## Issue List

**03-02-26 CULVERS - MESA, AZ**

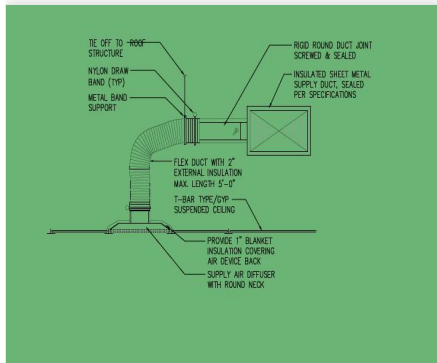
**Issue Name :** NONFUNCTIONAL/INACCESSIBLE DAMPERS  
**Description :** SGRD1-7: Flow varies between 345-380cfm regardless of lever movement (DR). Some dampers are covered by insulation and the zip tie.  
**Created By :** National TAB                      **Assigned To :** National TAB - Brianna Biggs  
**Status :** Open  
**Priority :** Urgent                                      **Asset Tag :** SGRD7  
**Originated Date :** 03/06/2026 - Christine Weale - National TAB
